**LAND AT BIRD IN EYE FARM, SOUTH OF BIRD IN
EYE HILL, FRAMFIELD, UCKFIELD, EAST SUSSEX**

**REBUTTAL PROOF OF EVIDENCE OF RICHARD
WHITE**

**APPEAL BY KASSIE SMITH KC
TOWN AND COUNTRY PLANNING ACT 1990
LPA REF: WD/2021/2198/MAO
PINS REF: APP/C1435/W/22/3307820**

Figure 2.1: 11.2m Refuse Vehicle Swept Paths

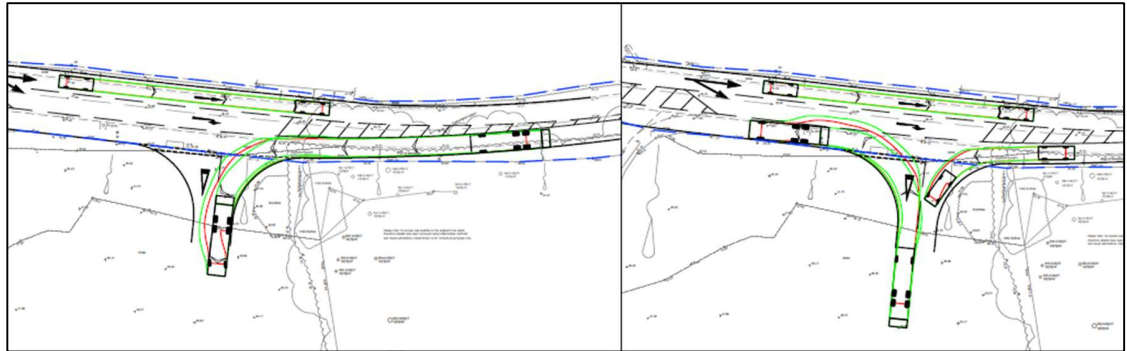
- 2.4 The swept paths of an 11.2m refuse vehicle, a 12m rigid truck and 16.5m articulated vehicle (in Appendix 28 of Mr Twinberrow's evidence) show that these vehicles will encroach beyond their lane and so are not acceptable in terms of highway safety. This not only occurs on the access road but also on Bird in Eye Hill for vehicles turning left out of the site. **Figure 2.1** overleaf provides an extract from the swept path assessment for an 11.2m refuse truck and **Figure 2.2** overleaf for an articulated vehicle.

- 2.5 As these vehicles will visit the site regularly (and could increase if the type of businesses at the farm changes), these encroachments will also occur on a regular basis and will create a road safety hazard for all road users.

- 2.6 Mr Twinberrow states in his Hearing Statement (February 2023) at paragraph 2.52 that eastbound cyclists travelling to the appeal site will utilise the vehicular access (rather than the NMU link to the northwest, which is stated to be westbound only) and so the regular over-running by larger vehicles will be particularly hazardous for cyclists.
